Inspection Report for
B-52-084 (BENSON HOLLOW)

STH 56 over UPPER CAMP CREEK
Mar 05,2018

BRIDGE PLAN OF DEFICIENT AREAS

CORRESPONDENCE WITH DOT FOR BRIDGE REPAIRS

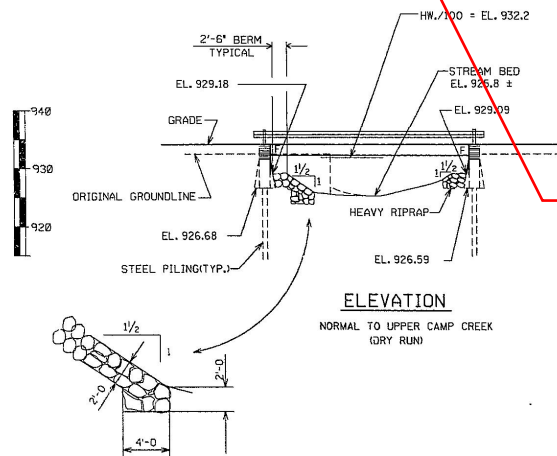
Spall in abutment face at joint with slab. Typical at north end of both abutments.

Spalling concrete at top of north slab edge, along line of surface repair completed in 2015.

Approx. 65 SF of Delamination in deck wearing surface at time of 2016 routine inspection. Most of delamination near C/L and WB lane.

Sediment starting to build up in channel under bridge.

No.	Date	Revision	By
STATE OF WISCONSIN DEPARTMENT OF TRANSPORTATION DIVISION OF HIGHWAYS			
STRUCTURE B-52-84			
Const. 1981	Drawn ZARK	Files Checked FWG	
STEEL RAILING TYPE 'W'		SHEET 8 OF 8 X78939

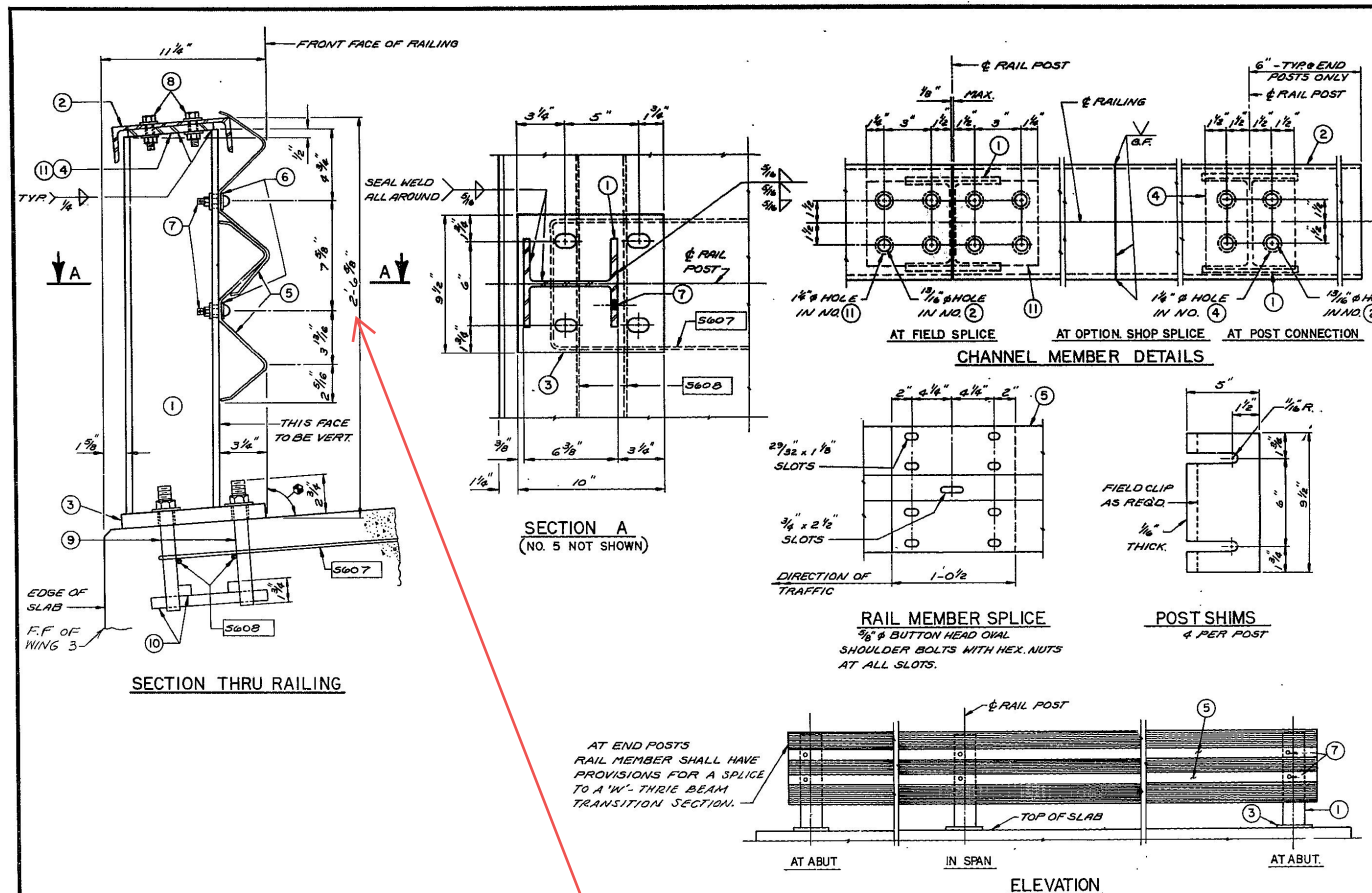
Steel W Rail height does not meet current standards
